Manual Supplement

Manual Title: 724 Product Overview

Part Number: 1547851

Supplement Issue: 3

Figure 4.

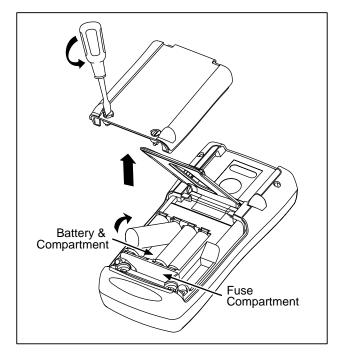
On page 9, replace Figure 4 and add the following text:

Replacing the Fuses

The calibrator comes equiped with three 0.05A 250V socketed fuses to protect the calibrator.

The fuses can be removed and checked for resistance. A value of $< 10~\Omega$ is still good. Problems while measuring with the right jacks indicate that F3 may have opened. Problems while measuring or sourcing with the center jacks or the TC jacks indicate that F2 may have opened. If you can't measure or source current with the left jacks, F4 may have opened. To replace the fuses, refer to Figure 22 and perform the following steps:

- 1. Turn the calibrator off, remove the test leads form the terminals, and hold the calibrator face down.
- 2. Using a flat-blade screwdriver, turn the battery door screws 1/4-turn counterclockwise and remove the battery door.
- 3. Remove and replace the damaged fuse.
- 4. Replace the battery door and secure it by turning the screws 1/4-turn clockwise.

Figure A.

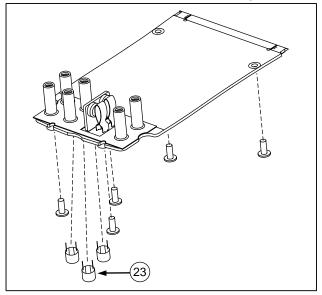
On page 10, Figure 5, add the view of the fuses as shown in Figure A.
